Report No. EGG-EA-5369

Adequacy of Station Electric Distribution System Voltages, Edwin I. Hatch Nuclear Power Station - Unit Nos. 1 and 2, Docket Nos. 50-321 and 50-366, TAC Nos. 12831 and 12832

ADEQUACY OF STATION ELECTRIC DISTRIBUTION SYSTEM VOLTAGES

EDWIN I. HATCH NUCLEAR POWER STATION - UNIT NOS. 1 AND 2

HATCH STATION  
UNIT ONE LINE DIAGRAM  
FIGURE 1

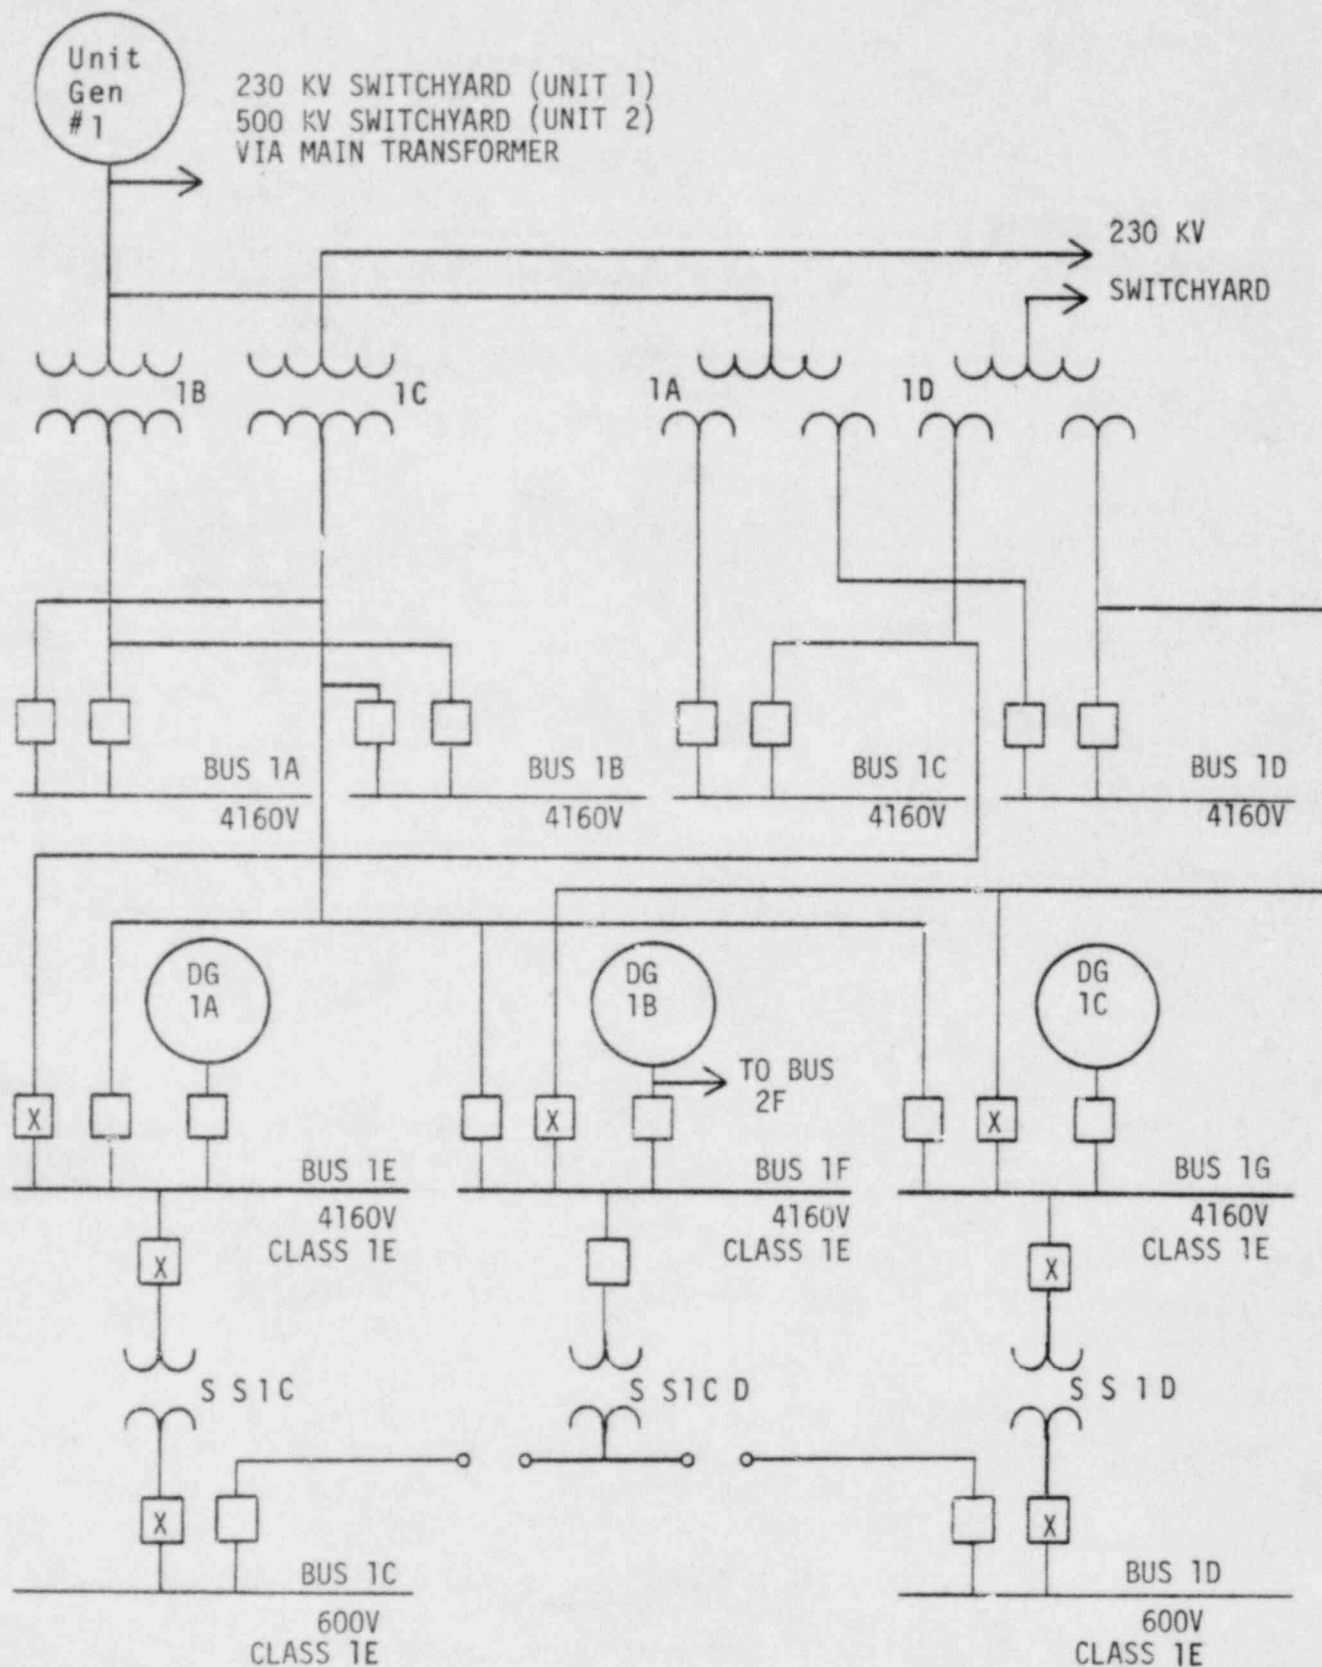
Figure 1 is a simplified sketch of the unit one-line diagram taken from Sheets 5-60 and 5-61 of the Reference 2 attachments. The distribution systems for Unit 1 and Unit 2 are identical. The Unit 1 class 1E 4160V buses can be supplied offsite power from the 230kV switchyard by startup transformers 1C or 1D. These buses cannot be connected to the unit auxiliary transformers 1A or 1B.

The two class 1E 600V buses 1C and 1D are each normally connected by 4160/600V transformers to class 1E 4160V buses 1E and 1G, respectively. An identical 4160/600V transformer, connected to class 1E 4160V bus 1F can be connected to either 600V bus 1C or 1D by disconnect links. The FSAR indicates that procedures prevent both 600V buses being connected to the same transformer or being operated in parallel. Class 1E buses 1C and 1D supply essential power to the 120/208V AC instrument power system by two separate transformers. While the instrument power system supplies both essential and non-essential loads, Section 8.3.1.1.4a of the FSAR indicates that failure of a nonessential load will not affect the ability of the system to supply the essential (class 1E) loads.
